**RE: DA8.2020.24.1 – RESPONSE TO COUNCIL LETTER  
PROPOSED WOOLWORTHS METRO, 731-741 MILITARY ROAD, MOSMAN**

This letter has been prepared by Ethos Urban on behalf of Fabcot Pty Ltd ('Fabcot') in response to the letter issued by Mosman Council (Council) on 20 May 2020, requesting additional information in relation to Development Application (DA) 8.2020.24.1 for the proposed Woolworths Metro store at 731-741 Military Road, Mosman.

**Figure 1    Updated ground floor plan (right) showing lane widening (before and after)**

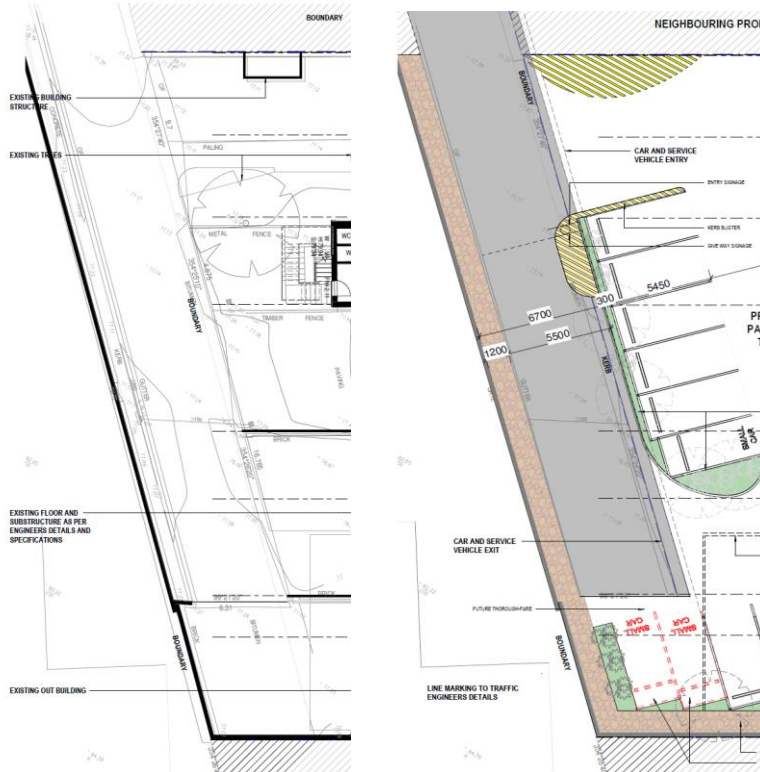
Section 7.6 of the Business Centres Development Control Plan (BCDCP) relates to lane and accessway widening and identifies that Lennon Lane is subject to Council's lane widening program. The road dedication for 741 Military Road remains pending. This section of land is required to be dedicated to Council. The design of the proposal is required to be amended to accommodate this dedication.

The design has been amended to facilitate the widening of Lennon Lane as requested by Council. This involves the widening of the laneway to the east to facilitate a total road reserve of 6.7m (carriageway of 5.5m), and the construction of a 1.2m footpath along the western side of the laneway, crossing the lane, passing through the southern portion of the site, and continuing through to Military Road. This is shown in **Figure 1** below. The widening and footpath are proposed to be constructed up to and in line with the boundary of the RSL site to the north.

**Figure 3**    Visualisation of presentation of the proposal to Military Road

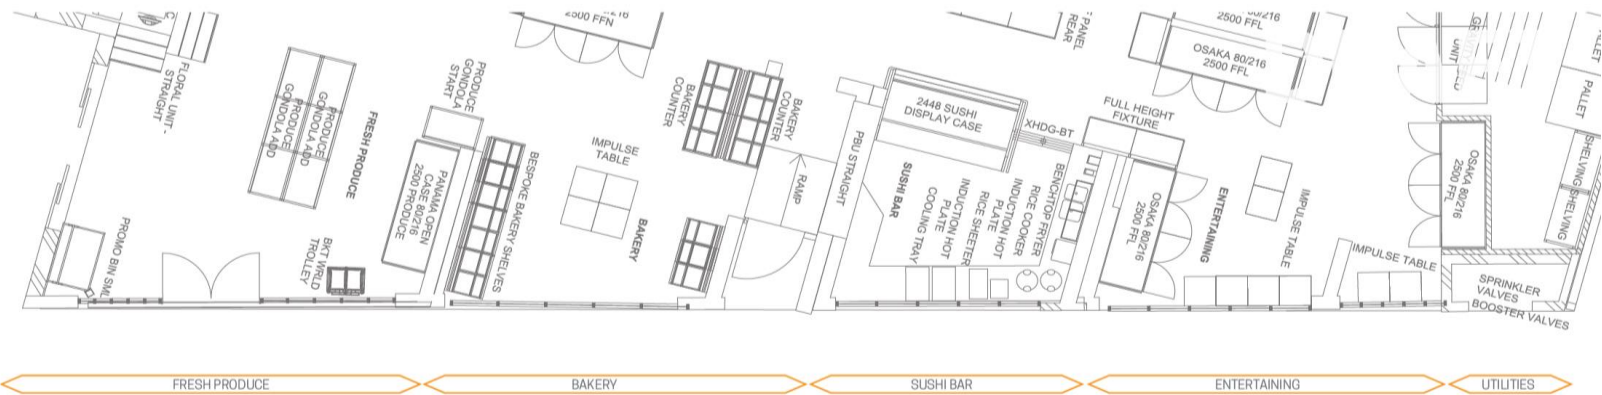
Item and description	Response										
<p><b>5. Active street front (Military Road)</b></p> <p><i>The DCP requires that street frontages provide a continuity of active business uses at street level. Further detail is required in terms of how the proposal satisfies Planning Controls P27, P28, P29 and P30 at Section 5.2 of the BCDCP</i></p>	<p>In order to respond comprehensively to Council's request, further assessment of Planning Controls P27, P28, P29 and P30 from Section 5.2 of the DCP is provided below:</p>

<table><tr> <th data-bbox="394 327 875 363">Control</th> <th data-bbox="875 327 2027 363">Assessment</th> </tr><tr> <td data-bbox="394 491 875 560"><i>P28. Facades to streets are to have shopfront clear glazing.</i></td> <td data-bbox="875 491 2027 560">Clear glazing is proposed to each of the facades of the individual shopfronts, as shown in the architectural drawings and depicted in the CGI in <b>Figure 3</b>.</td> </tr><tr> <td data-bbox="394 683 875 837"><i>P30. Window displays, display cases and well-defined pedestrian entries are encouraged at street level to provide pedestrian interest.</i></td> <td data-bbox="875 683 2027 837">As per the ground level fit out drawings, window displays will be utilised, as well as three well defined pedestrian entries from Military Road. The pedestrian entries are prominent, with the main entry to the supermarket well defined and highly visible from Military Road. These features in tandem will provide visual interest and interactivity and activity at street level. The CGI in <b>Figure 3</b> provides a good visual illustration of the visibility of the entry from Military Road.</td> </tr></table>

**Figure 4    Excerpt from ground floor plan showing through site link**

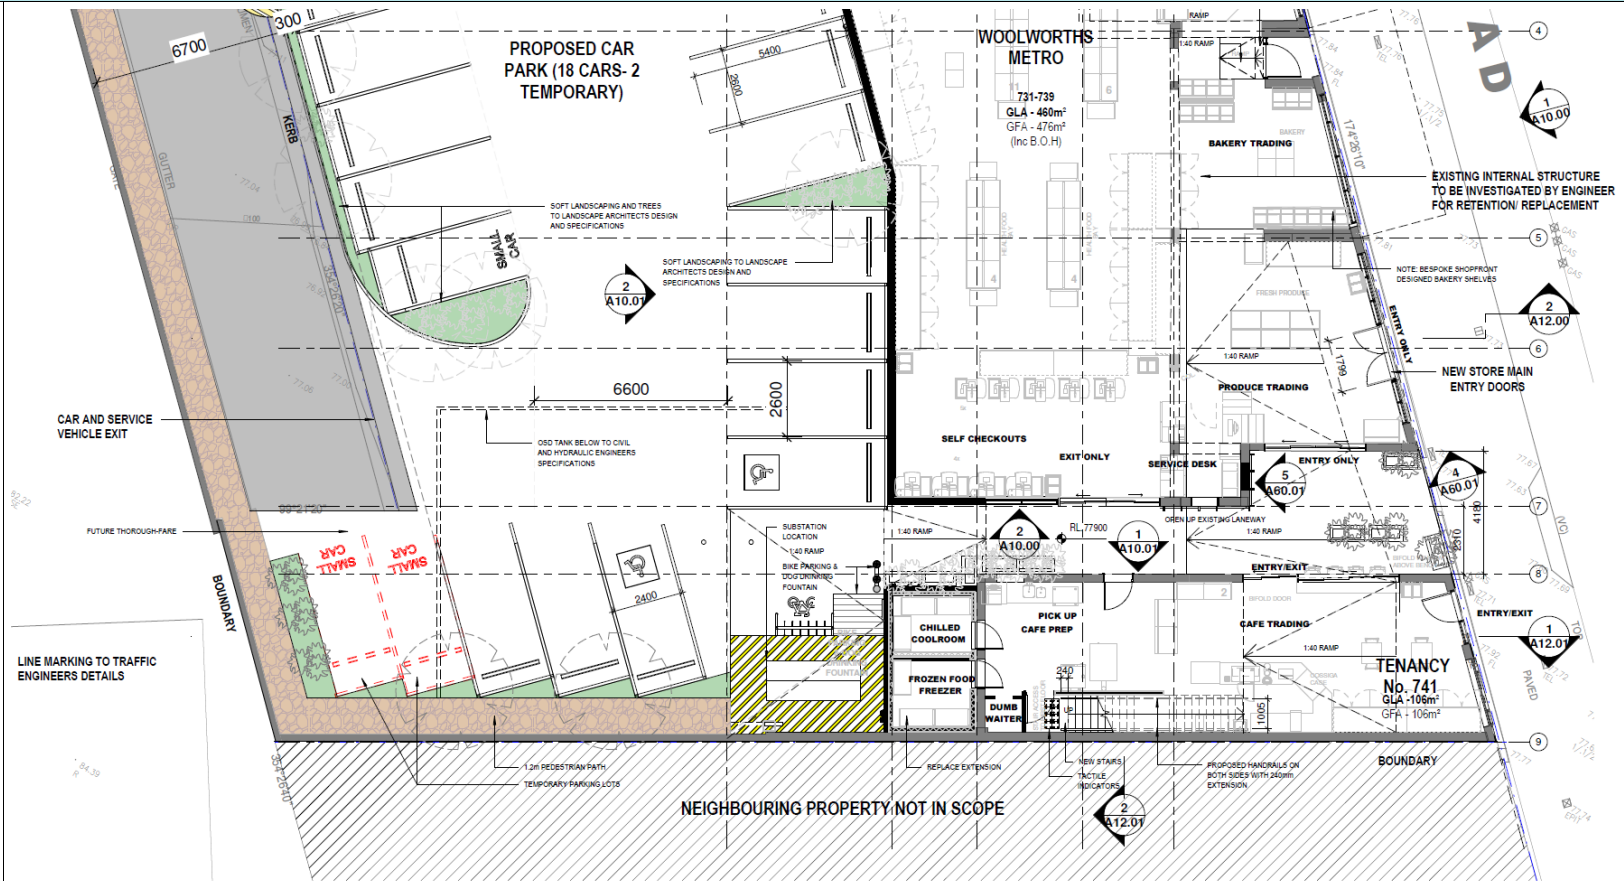
between Military Road and Lennon Lane that is designed in a manner that will provide for pedestrian amenity and safety. Detail should be provided in terms of the materiality of the through-site link and the link should be designed to match or be sympathetic to the Military Road streetscape, i.e. paving, lighting, seating, bollards.

**Figure 5    Revised rear elevation, demonstrating incorporation of architectural elements and new windows to improve presentation**

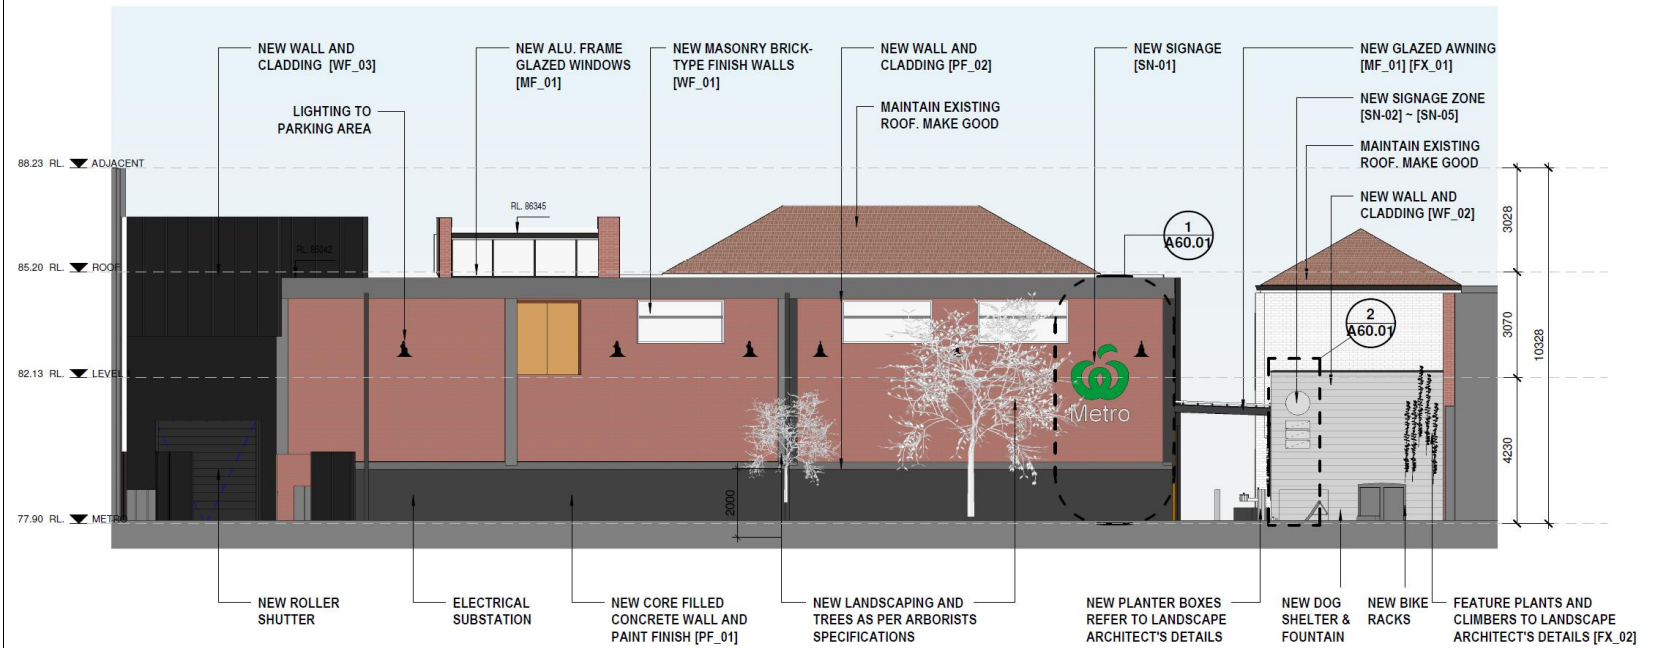
The proposal presents a two storey wall to the rear with little relief or detailing. The proposal should be amended to provide a more considered

*architectural character to the rear that reflects the desired use of Lennon Lane as a pedestrian link between Military Road and Gouldsbury Street by providing for pedestrian amenity and safety whilst mitigating amenity impacts to the neighbouring residential development.*

Amendments have been made to the rear elevation to break up the expanse of the rear wall and provide contrasting elements, as shown in the revised architectural drawings (**Attachment A**). The changes provide greater visual interest to the rear of the site, through the incorporation of new architectural elements to 'break down' the brick wall. The key elements include:

- the addition of three large windows to the rear façade, providing a glazed element to the façade and making it active;
- introduction of two vertical cladding elements to break up the width of the façade in recognition of the three buildings which make up the wider structure at its frontage;
- introduction of a darker horizontal painted element along the full extent of the façade at pedestrian level, breaking up the vertical expanse of the facade
